**SUBJECT: Variance Request for Final Clarification Sizing  
Wastewater Treatment Facility Improvements  
Osage, Iowa**

## VARIANCE REQUEST

RE: Variance Request for Final Clarification Sizing  
Wastewater Treatment Facility Improvements  
Osage, Iowa

FIGURE #4  
 OSAGE W.W.T.F.  
 ALTERNATE #3

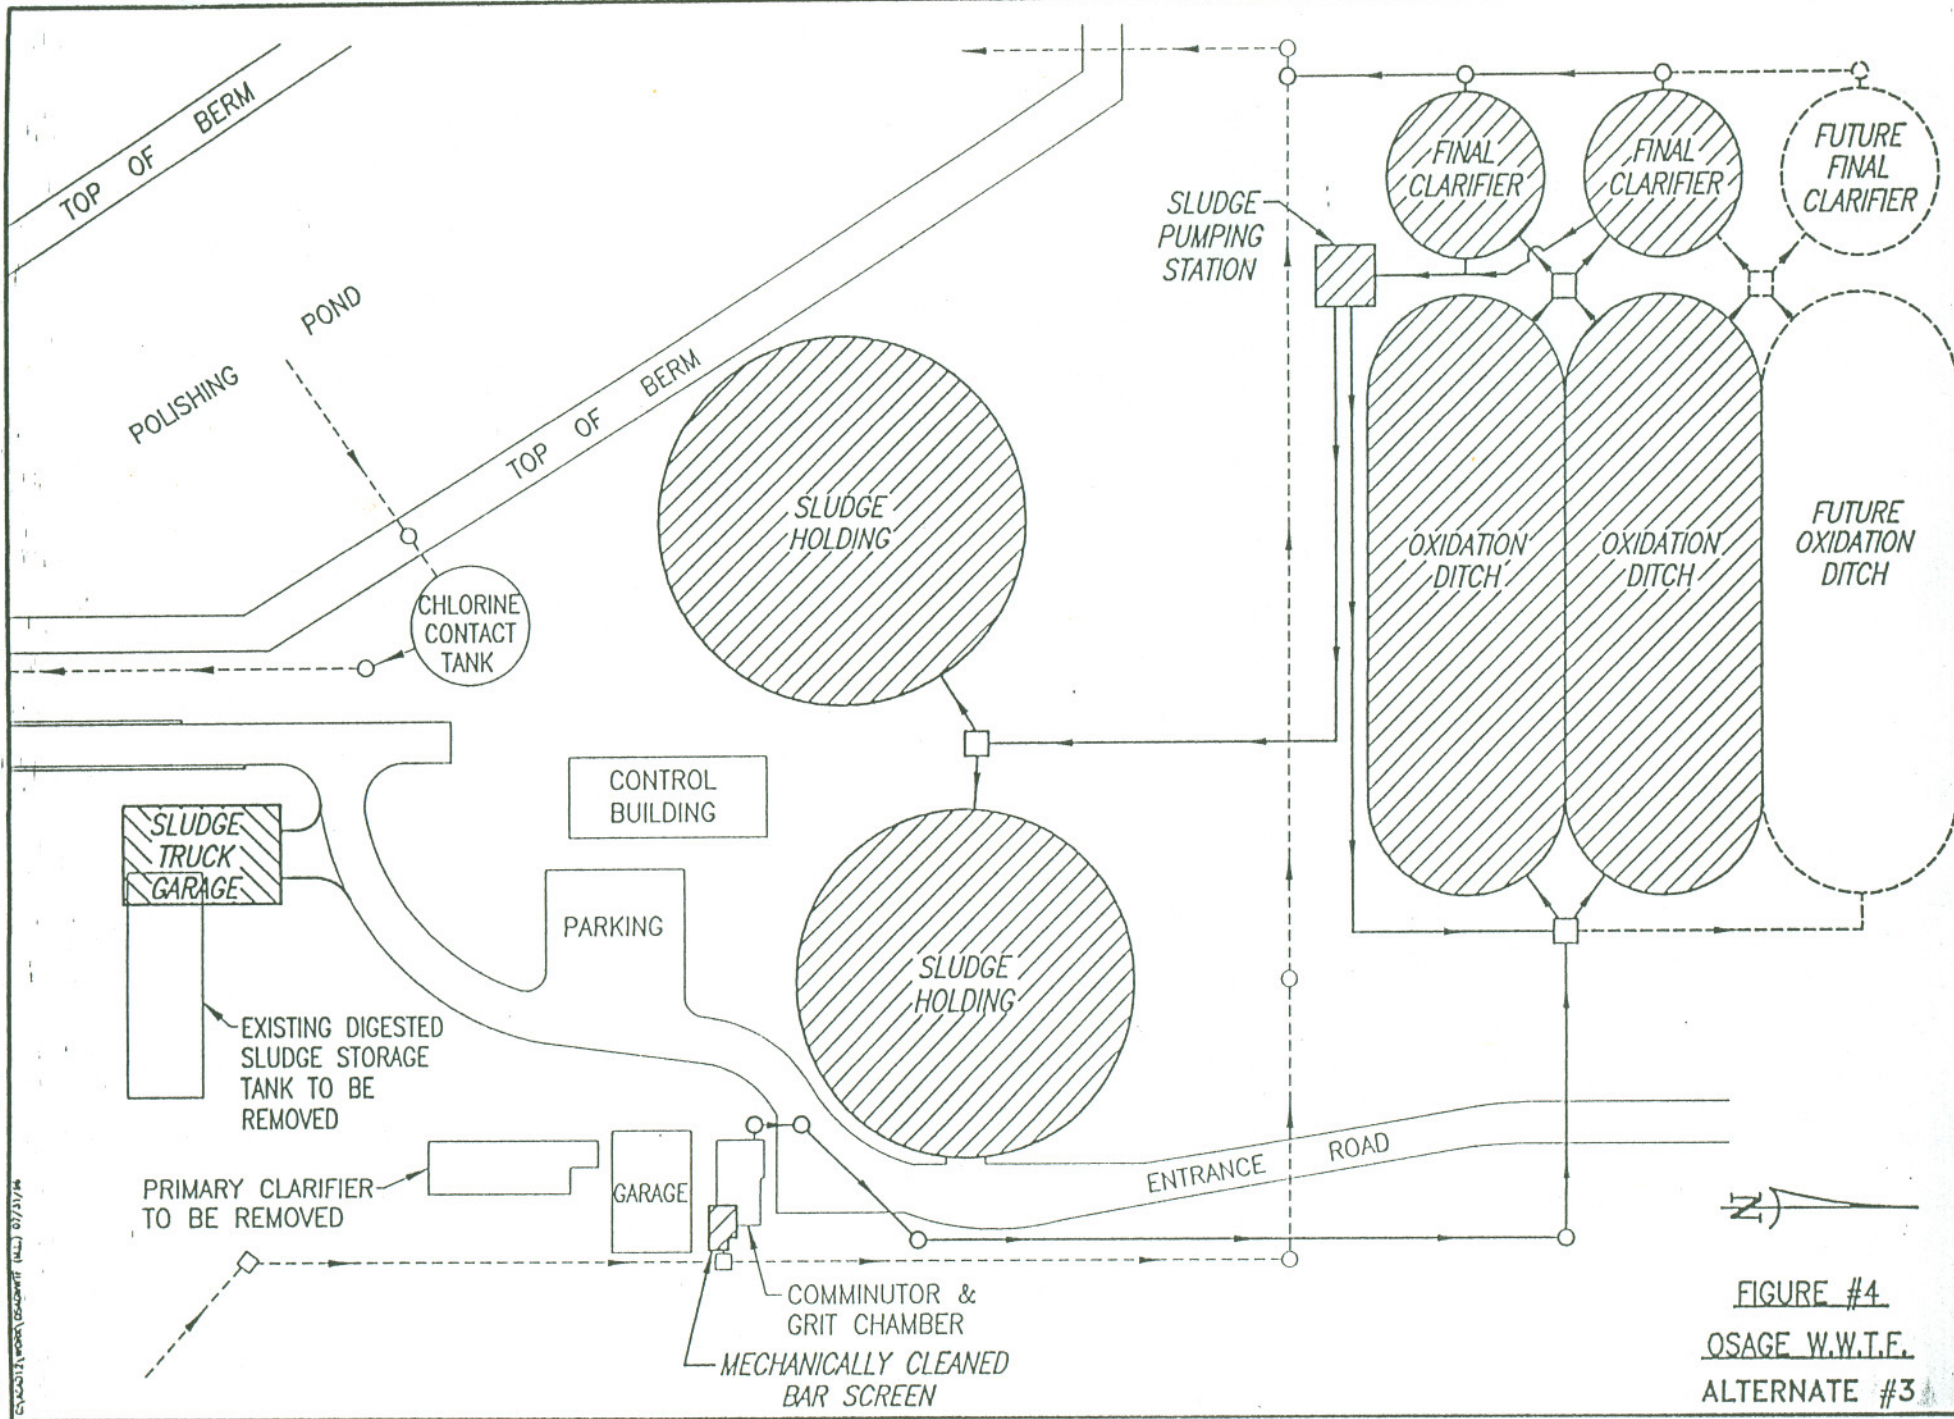
2, Yaggy Colby Associates wishes to take advantage of this polishing pond and the related hydraulic retention provide by such. The firm is proposing that each one of the two proposed final clarifier be designed based on 50% of the design flow rather than the 75% set forth in the Iowa Standards. It is the firm's opinion that a significant cost savings could be realized by the City of Osage should this variance be granted and the environment would be not subjected to any additional risk due to a wash out of a clarifier.

- 1. Rock excavation will be required for new final clarifiers.*
- 2. The proposed 38 ft diameter final clarifiers will each provide 75% reliability for PHWW flows of 1.512 MGD. For any PHWW flows in excess of 1.512 MGD, when only a single final clarifier is in operation, the additional solids removal through the existing 1.91 MG polishing pond should provide for treatment equivalent or better than reliability requirements.*
- 3. In a telephone conversation of 6/9/98 the designing engineer advised that Stamford baffles will be included in the design of the final clarifiers to increase solids removal.*
